**Nomination Form
Anadromous Waters Catalog**

Anadromous Waters Catalog Number of Water Body 247-41-10200-2053-3205-4067-5059-6010 (-0010)

Nomination #	25-538		<u>5/19/2025</u>
Revision Year:	2026		<u>5/19/25</u>
Revision to:	<input checked="" type="checkbox"/> Atlas <input checked="" type="checkbox"/> Catalog		<u>22 April 2025</u>
Revision Code:	C-5, C-8, A-2		<u>7/7/2025</u>
		Fisheries Scientist	Date
		Habitat Operations Manager	Date
		AWC Project Biologist	Date
		GIS Analyst	Date

Nom #25-538

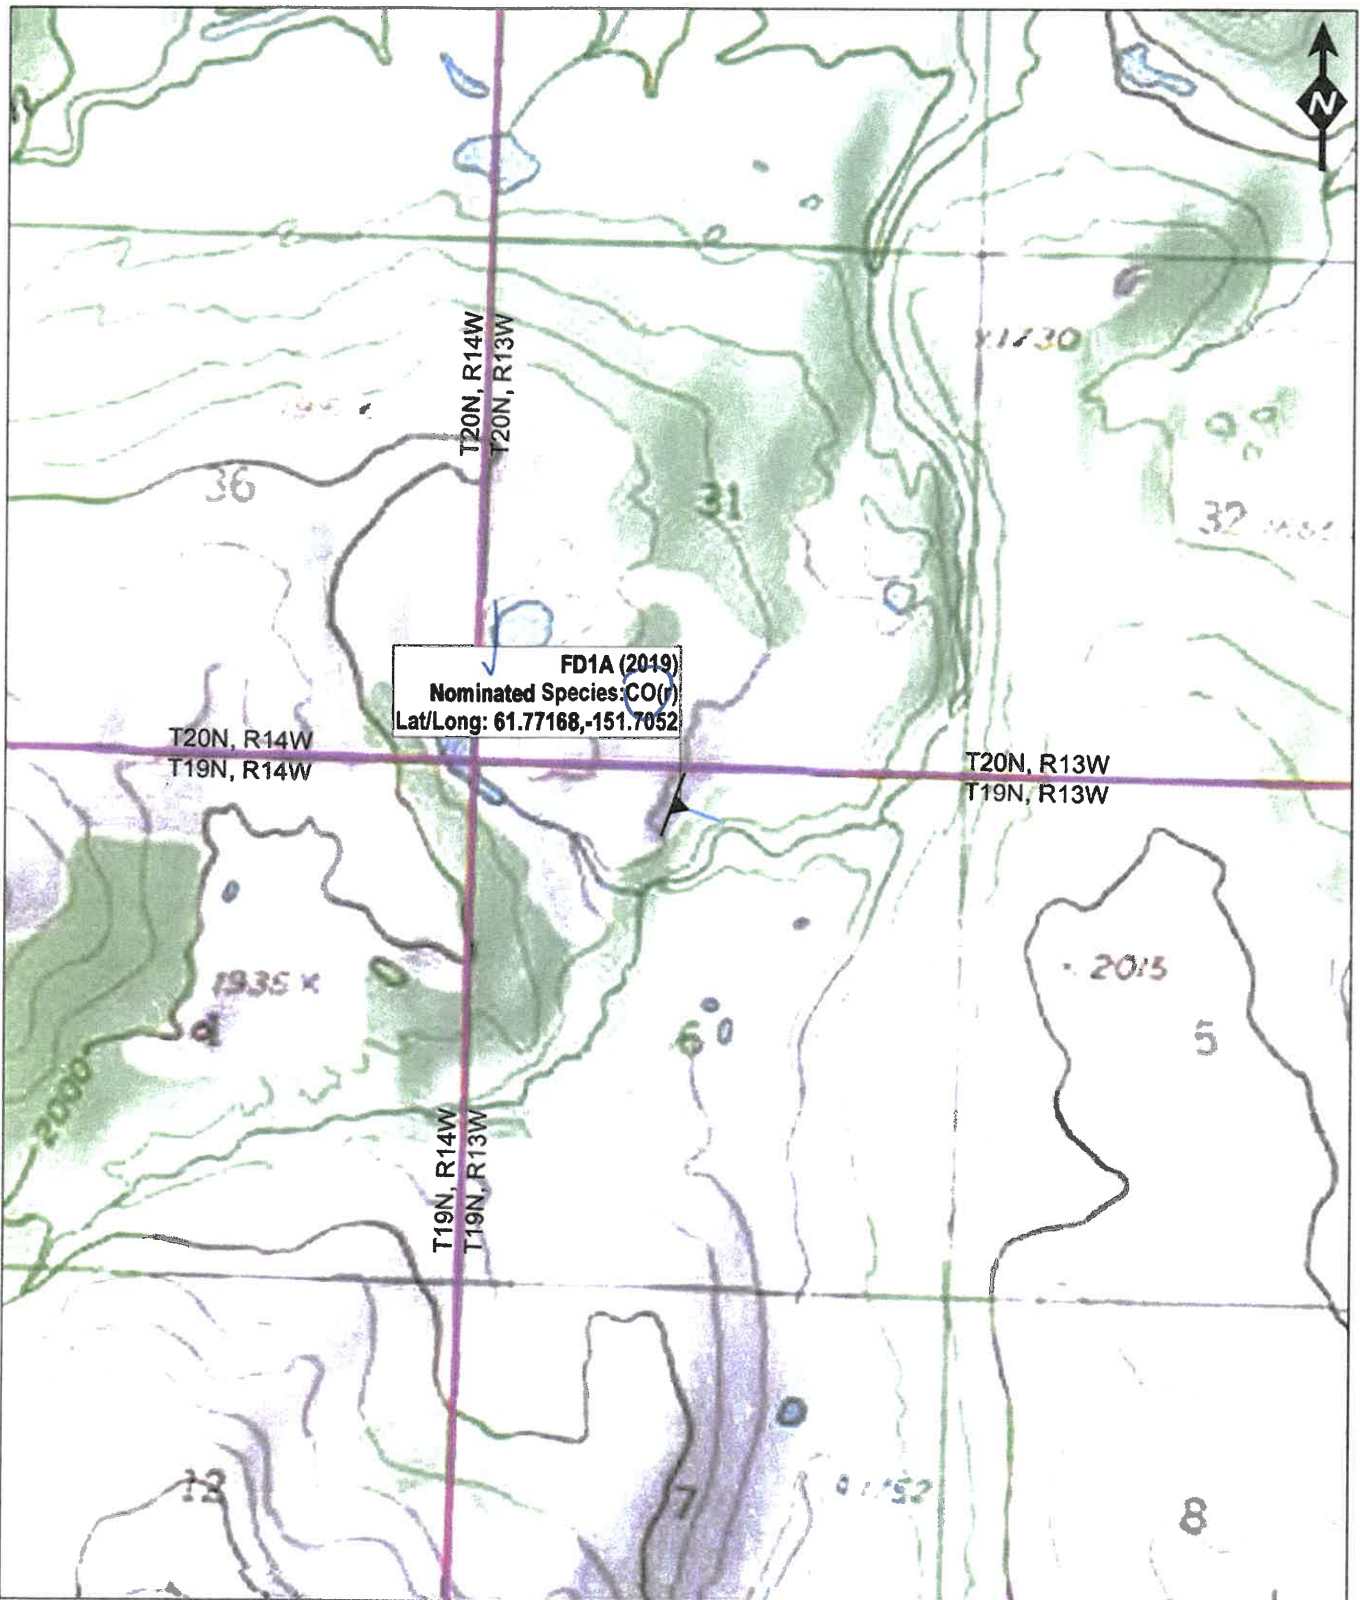
I do have a questions about the hydrography, it looks like the old point shown on your map did intend to map a new stream (-6010), but that doesn't appear to connect to the lake? (Current location of -6010)

Would I be moving the whole new stream (-6010) upstream to where you can see the hydrography flowing out of the lake and into -5059? (see image)

I am in the process of reviewing a plan for the Flatland Project in the vicinity of Canyon Creek (AWC# 247-41-10200-2053-3205-4067) and the unnamed stream (AWC# 247-41-10200-2053-3205-4067-5059). It looks like you made a number of AWC nominations in the area at the time. Did you also submit AFFI points? If so, could you send the AFFI form over to me? Did you any kind of follow up report of your findings? Also, do you have information on all the places you sampled but did not find anything? I'm particularly interested in these ponds that ponds in Section 31, T 20 N, R 13, SM and Section 36, T 20 N, R 14 W, SM that look like they feed into the unnamed anadromous stream in Section 6, T 19 N, R 13 W, SM. Did you do any eDNA work in the area or find any northern pike?

You are correct. The stream should be moved to where you indicated in red.

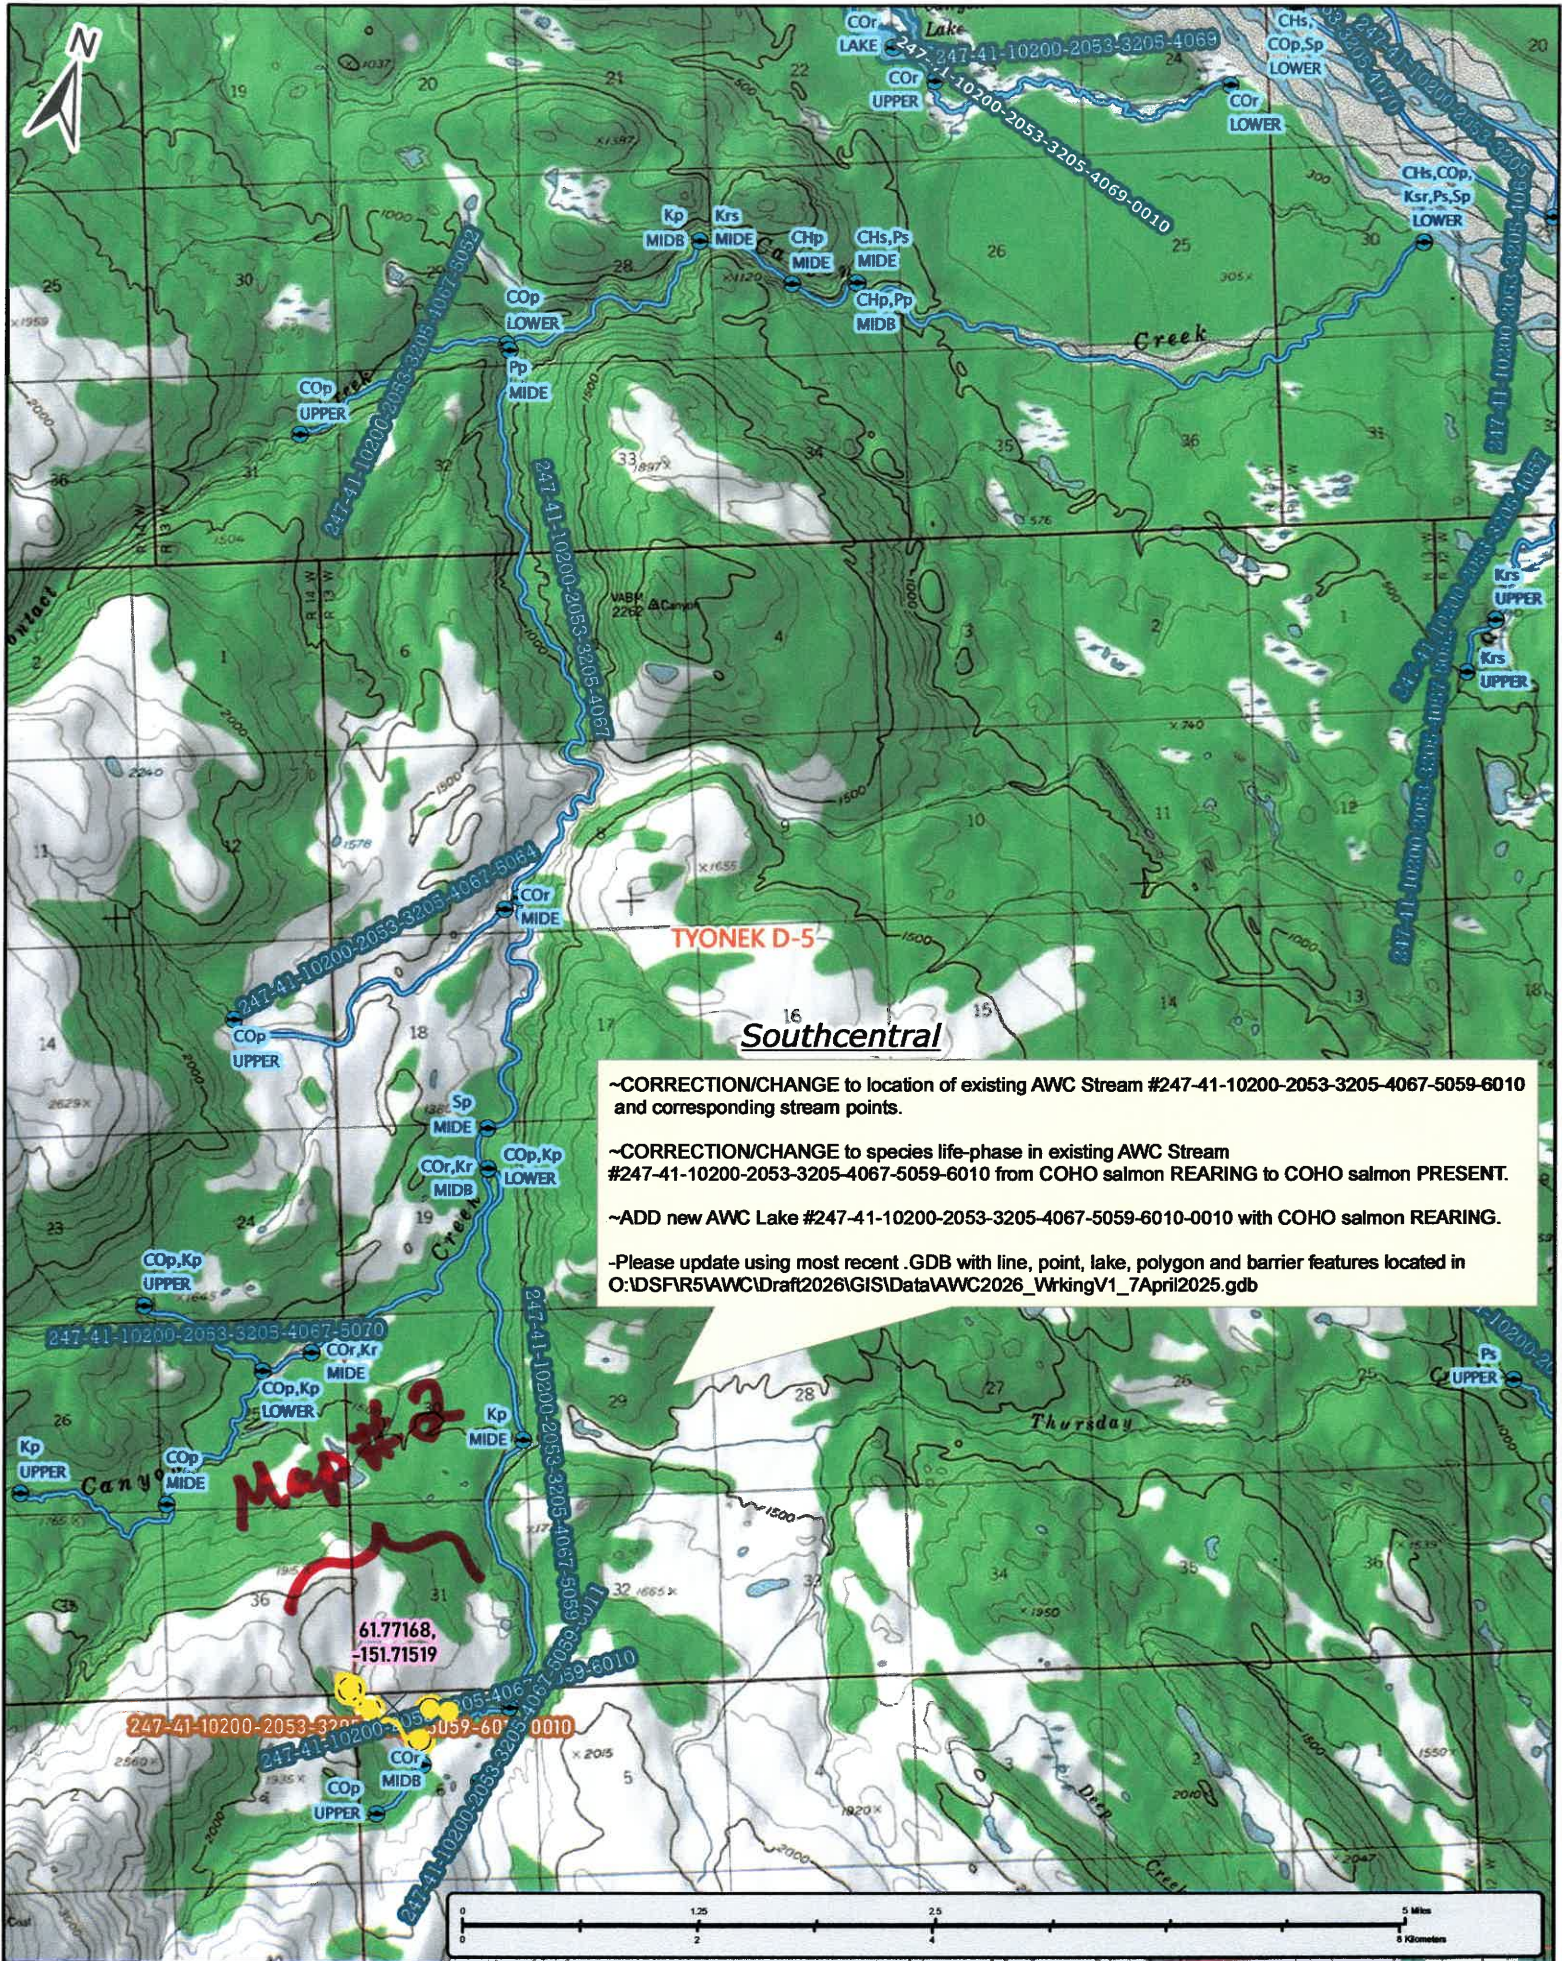
~CORRECTION/CHANGE to location of existing AWC Stream #247-41-10200-2053-3205-4067-5059-6010 and corresponding stream points.

~CORRECTION/CHANGE to species life-phase in existing AWC Stream #247-41-10200-2053-3205-4067-5059-6010 from COHO salmon REARING to COHO salmon PRESENT.

~ADD new AWC Lake #247-41-10200-2053-3205-4067-5059-6010-0010 with COHO salmon REARING.

DELETE old upper

DELETE old lower

-Please update using most recent .GDB with line, point, lake, polygon and barrier features located in O:\DS\FIR5AWC\Draft2026\GIS\Data\AWC2026_WrkingV1_7April2025.gdb
